ADDENDUM NO. 1

DATE OF ISSUANCE: July 24, 2026

PROJECT: City of New Albany Maryland Ave. Community Center
2020 Maryland Ave.
New Albany, IN 47150

ARCHITECT'S PROJECT NO.: 25-512.000

2 PLUMBING PLAN - DOMESTIC WATER
1/8" = 1'-0"

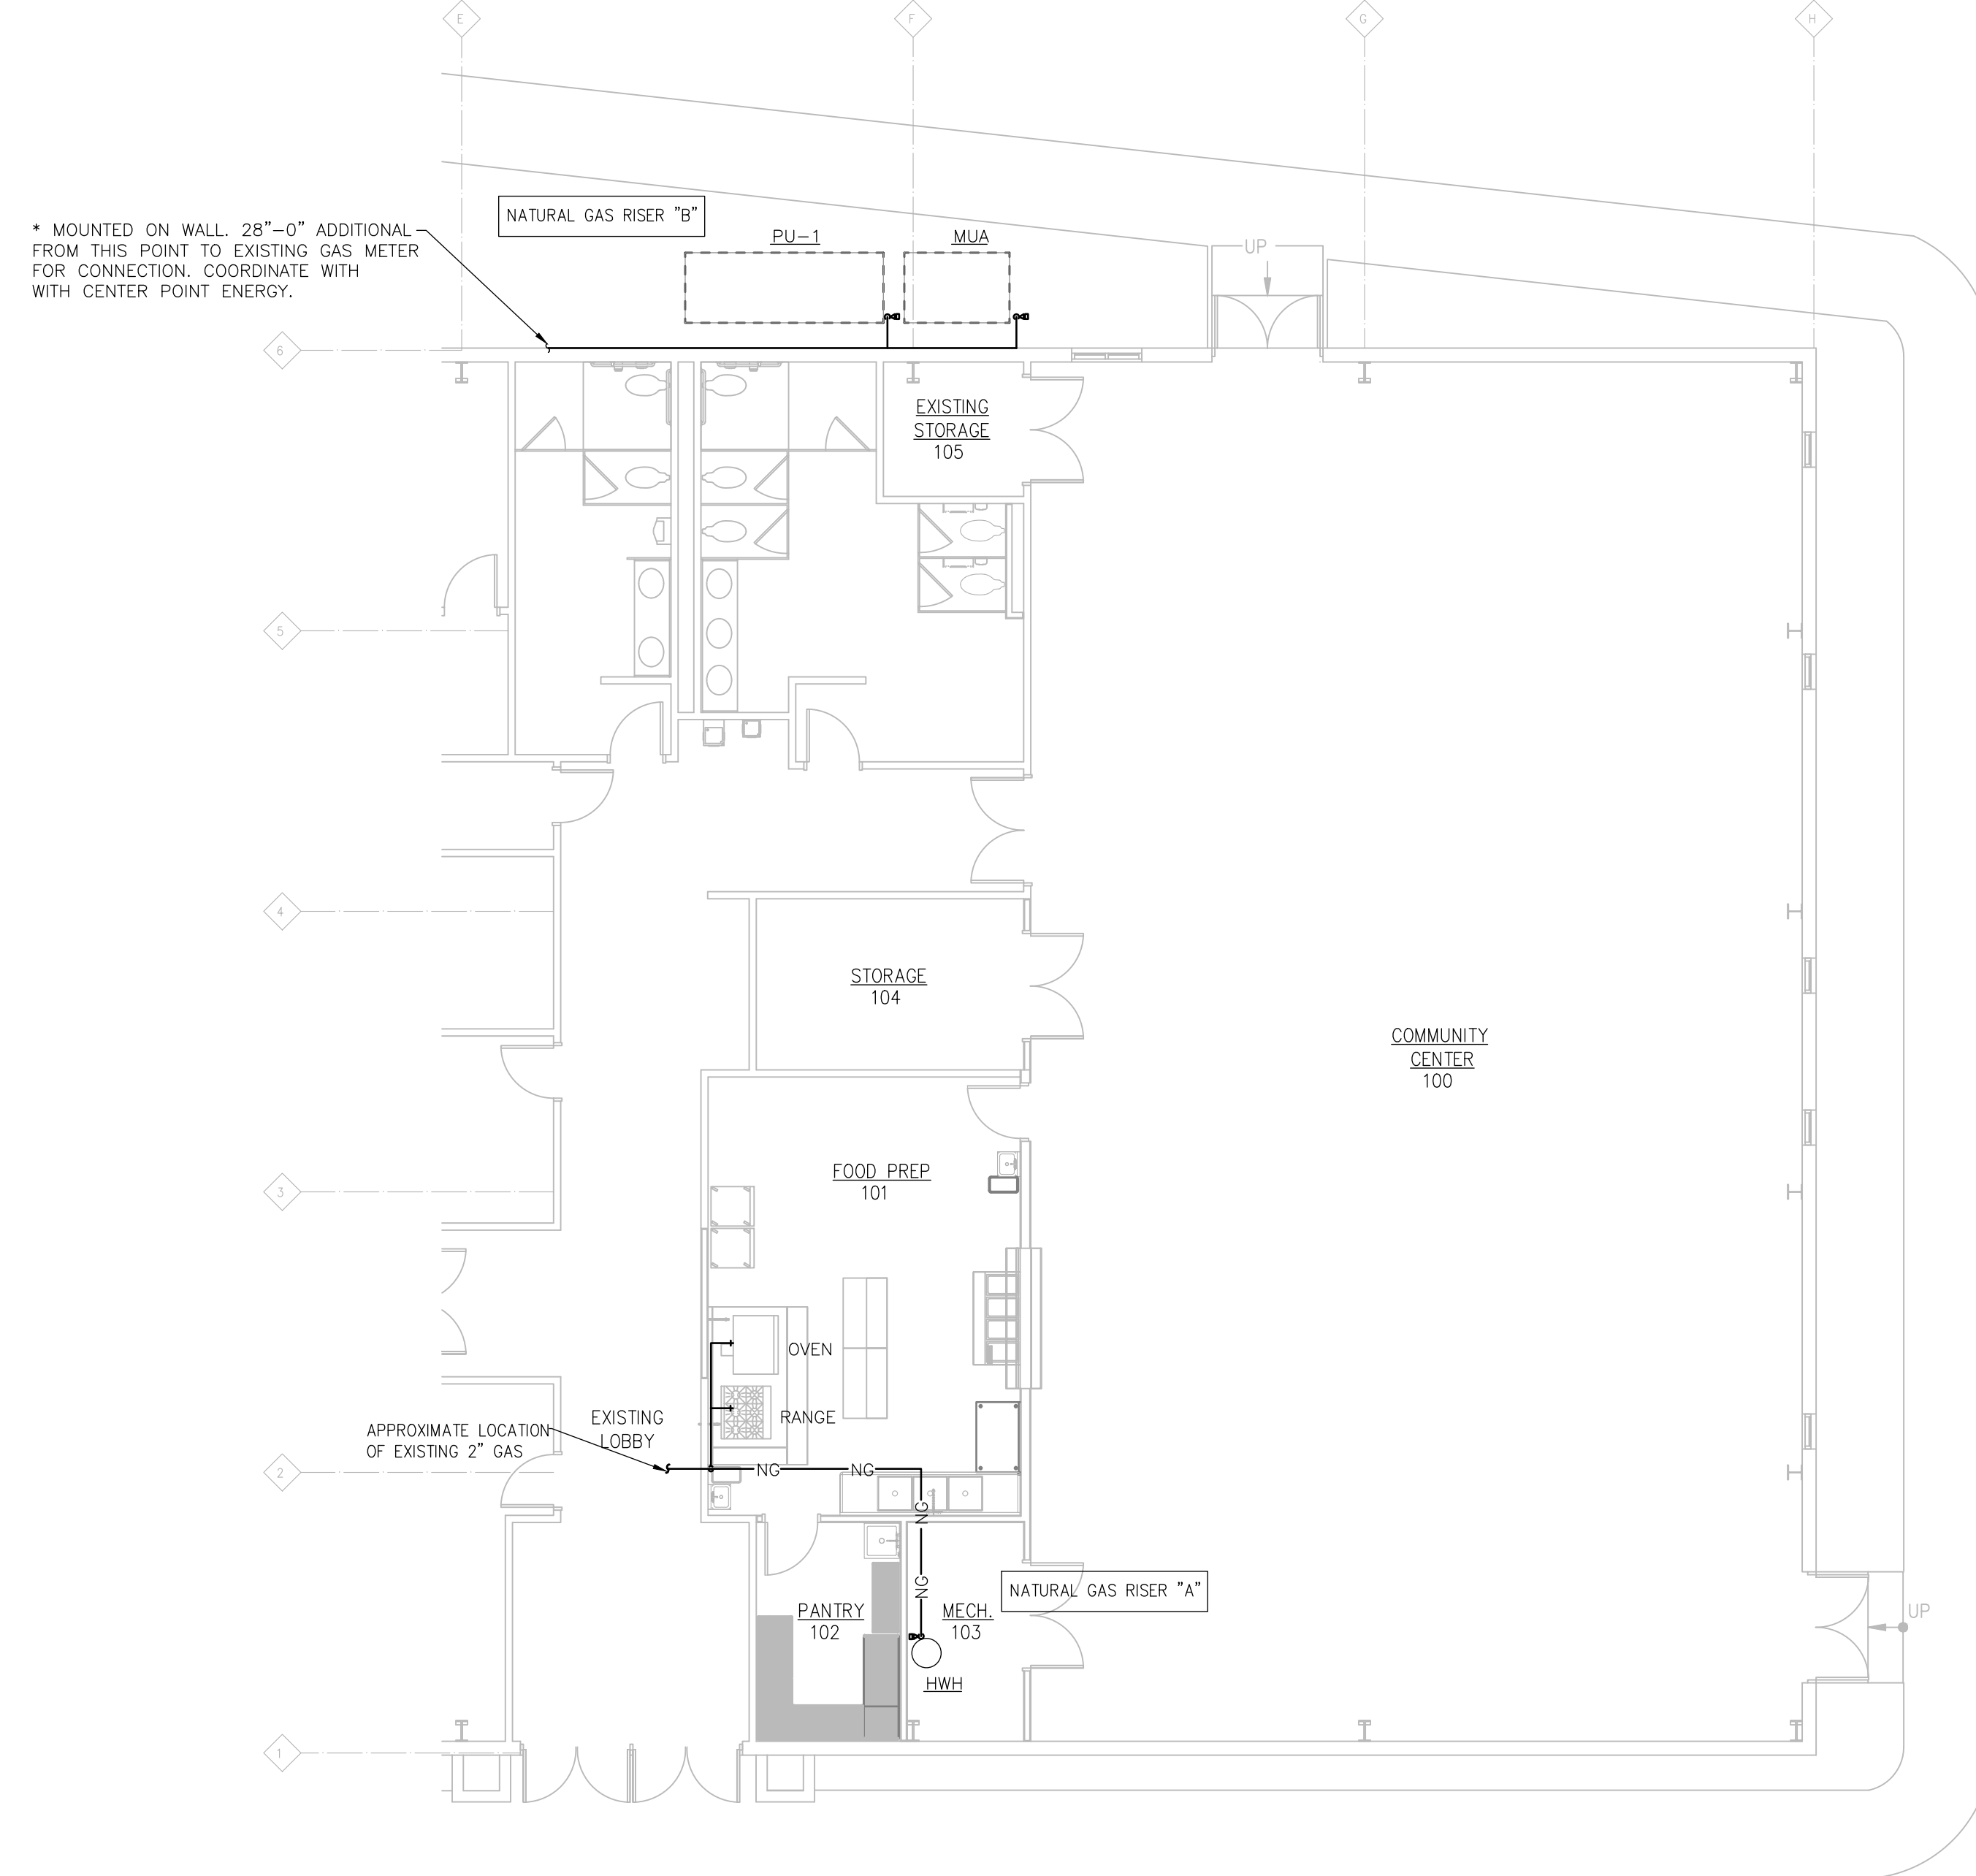
ADD-1 Item No. D-4 - Revised Existing Backflow Preventer Location

Sheets P 001 and P 101 dated 07/23/2026 have been revised to accurately represent the location of the existing backflow preventer in both plan and domestic water riser diagram.

COMMUNITY CENTER POWER PLAN - UNIT B

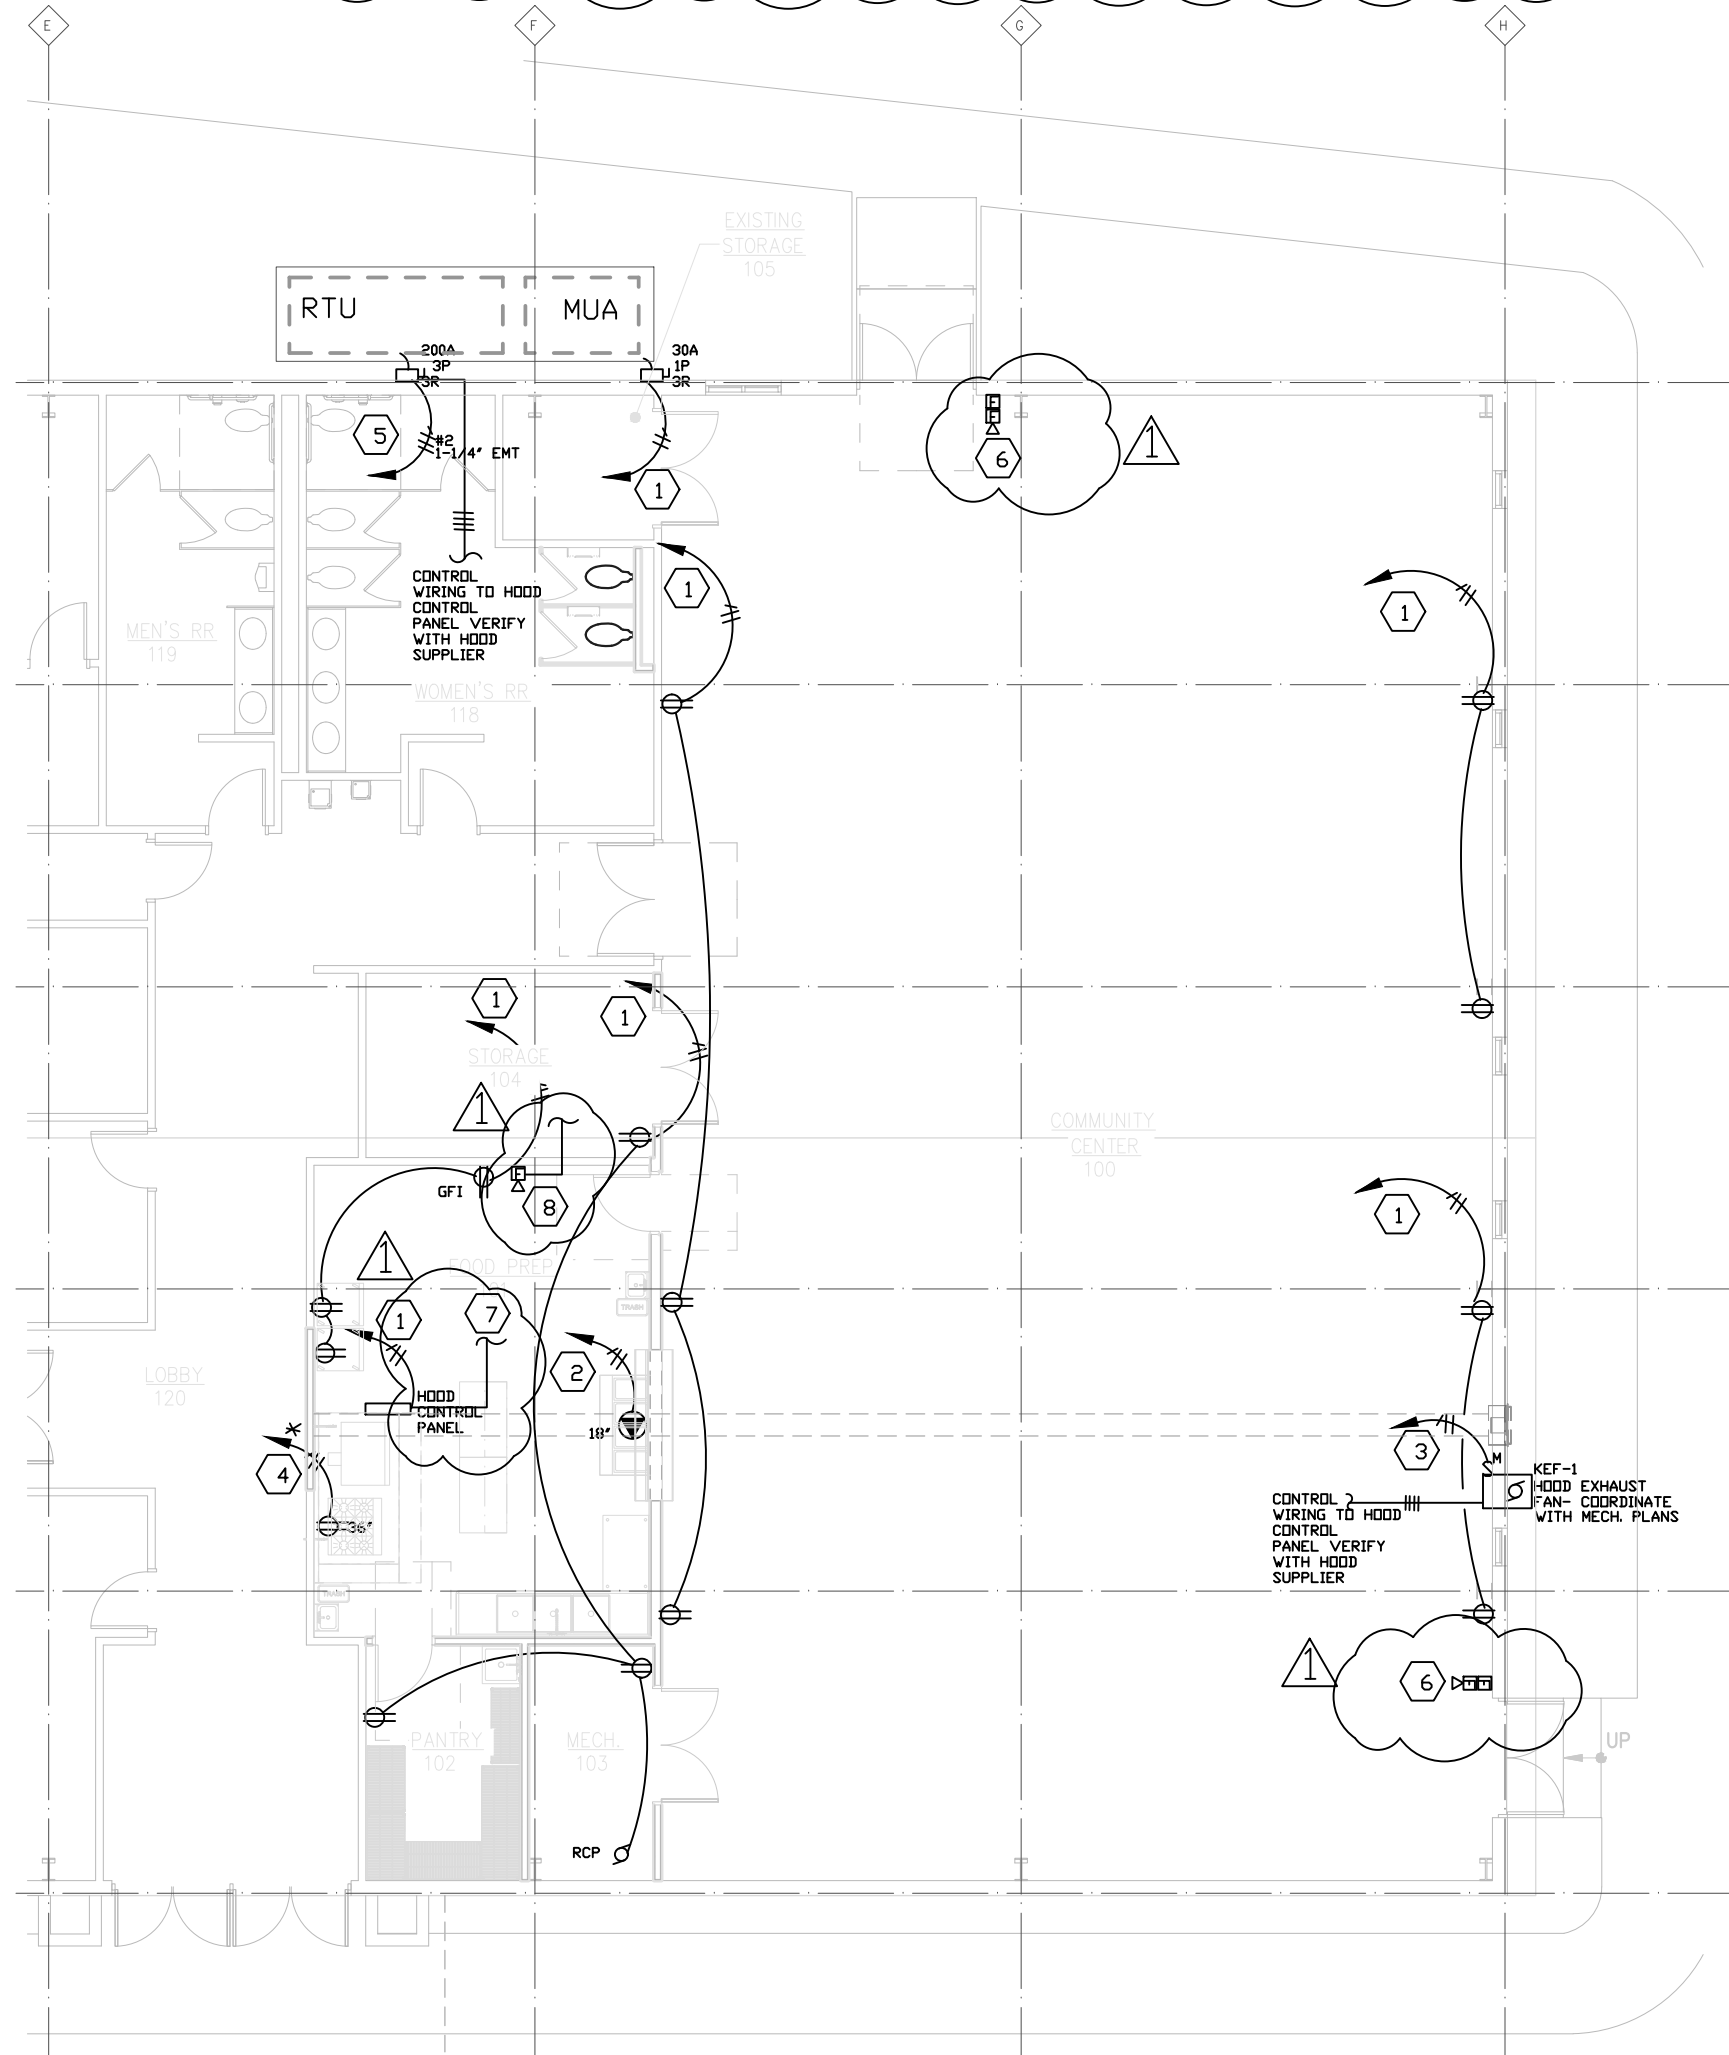
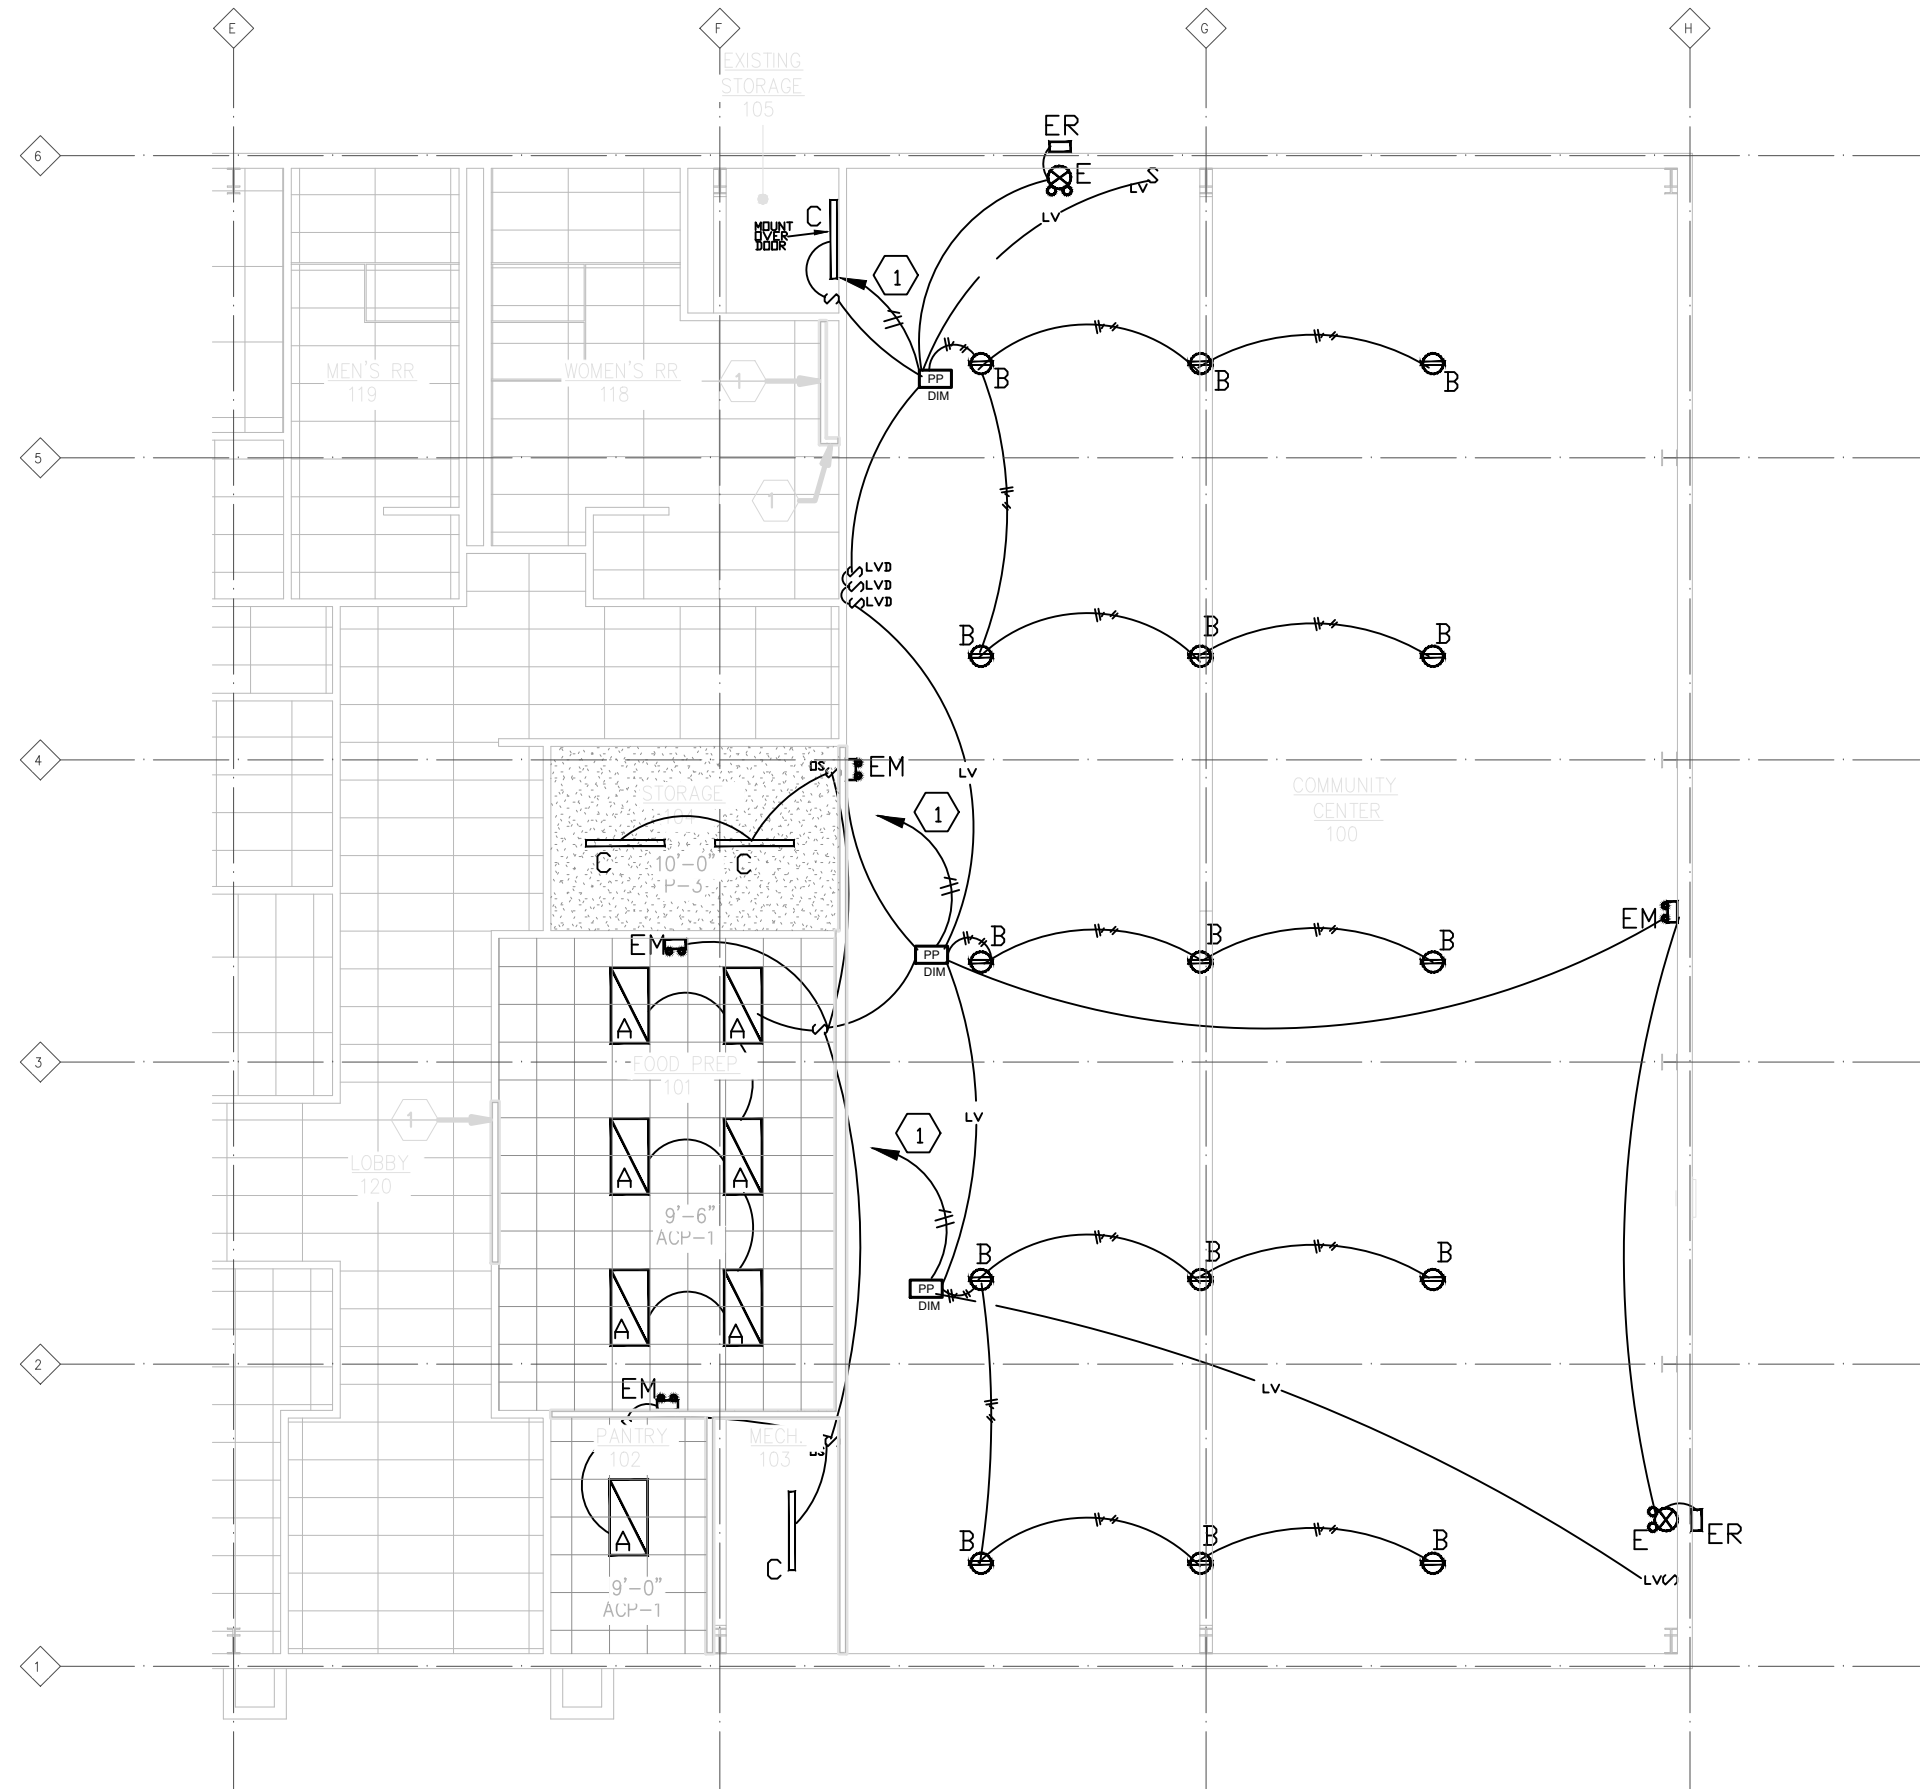
ADD-1 Item No. D-5 - Additional Fire Alarm Notation

Potential work at existing fire alarm pull stations and strobes has been noted and graphically represented on Sheet E 101 dated 07/23/2026.

- IF ARCHITECTURAL ALTERNATE 1X OR 1B IS ACCEPTED PROVIDE NEW RECESSED BACK BOX FOR EXISTING FIRE ALARM PULL STATION AND AUDIO VISUAL UNIT. RE-USE EXISTING WIRING AND MODIFY AS REQUIRED.
